Central Zoo Authority

F. No. 19-62/92-CZA(27)(Vol. VII)(M) / 4231

Sub:- Designs for the construction of various enclosures at Assam State Zoo, Guwahati.

The designs for the construction of various enclosures at Assam State Zoo, Guwahati was placed before the 46th Meeting of the Expert Group on Zoo Designing of the Central Zoo Authority held on 3rd January, 2014. After detailed deliberation, the design was approved subject to the following:-

PROPOSED HIPPOPOTAMOUS ENCLOSURE	
LOCATION: ASSAM STATE ZOO CUM BOTANICAL GARDEN GUWAHATI, ASSAM	
DRAWN BY: JUNU PRABHA KALITA	PREPARED BY: SRI. G.K. DEB, MEDH Assistant Engineer Assam State Zoo Division Guwahati-6
SCALE = 1:300, 1:100, 1:50	DATE =

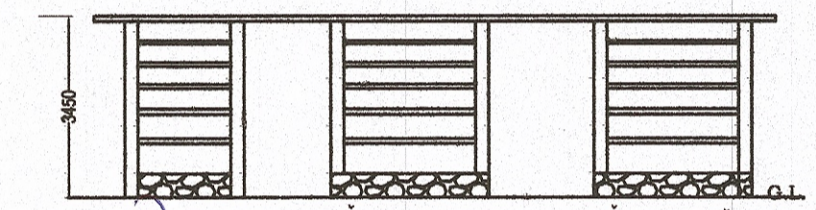
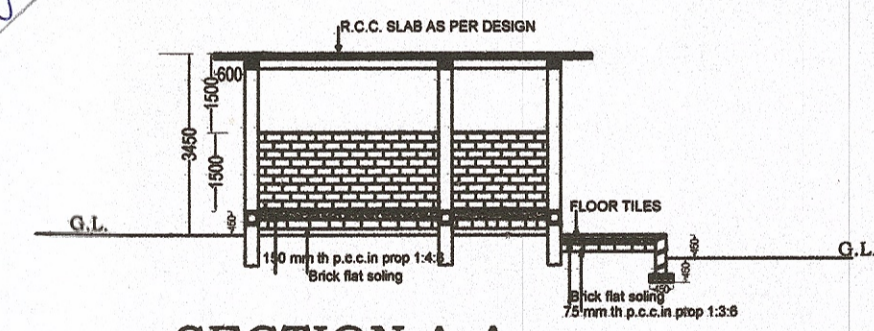
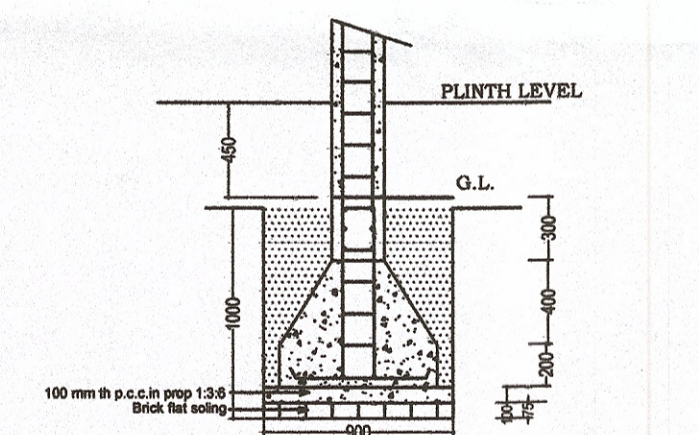
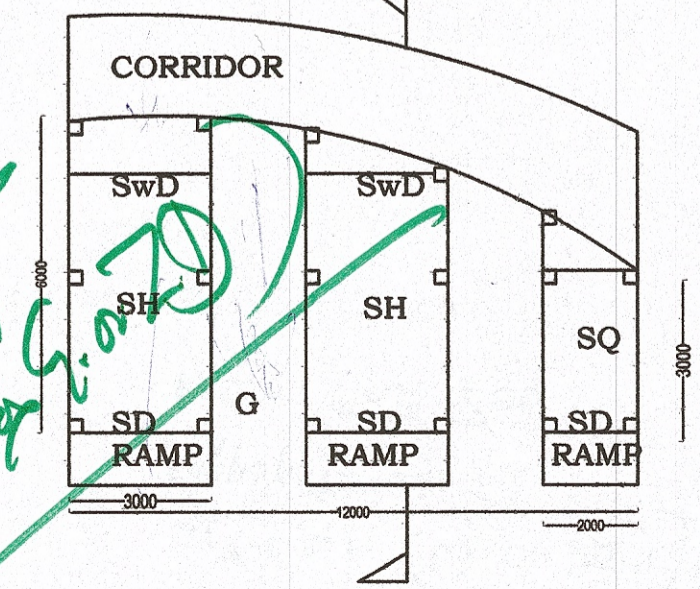
Approved subject to change following.

- Depth of tank should be minimum 2.0 mts (1.50 mts depth) (lower slope)
- Tank/water body area should be about 80% of the enclosure area
- width of corridor - First gate should be adequate for entry of cage.
- In case animal entry should be slide door
- There should be close land area about 3m wide to the visitors area.

60% water
